Product Change Notification

Additional Assembly/Test Location and Product Marking Changes for TBU® and TCS™ High-Speed Protectors

Table 1. Bourns® TBU® and TCS™ High-Speed Protectors

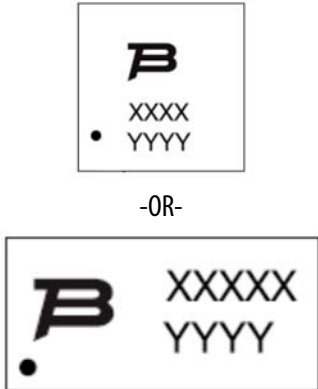
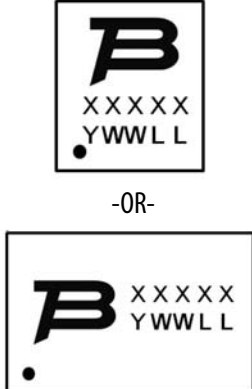
In addition, a change to the product marking will be made to Bourns® TBU® and TCS™ High-Speed Protectors to simplify and improve the ease of use. The changes are summarized in the table below.

<p>XXXX: 4 Digit Product Code 04GC: P40-G240-WH D042: TCS-DL004-250-WH D045: TCS-DL004-500-WH D047: TCS-DL004-750-WH</p> <p>XXXXX: 5 Digit Product Code</p> <ul style="list-style-type: none"> • 1st Digit indicates product family • 2nd & 3rd Digits indicate impulse voltage • 4th & 5th Digits indicate trigger current <p>YYYY: Manufacturing Date Code</p> <ul style="list-style-type: none"> • 1st Digit indicates the year's 6-month period • 2nd Digit indicates the week number in the 6-month period • 3th & 4th Digits indicate specific lot for the week 	<p>XXXX: 4 Digit Product Code</p> <ul style="list-style-type: none"> • 1st Digit Indicates product family 4 – for P40 8 – for P850 C – for C series D – for TCS-DL series A – for TBU-CA series T – for TBU-DT series L – for TBU-PL series • 2nd & 3rd Digits indicate impulse voltage • 4th & 5th Digits indicate trigger current <p>YWWLL: Manufacturing Date Code</p> <p>Y: Year WW: Week LL: Lot code</p>

There is no change to the fit, function, quality or reliability of the products. The change to the product marking only affects the product's form. The product labels will show the country of origin code.
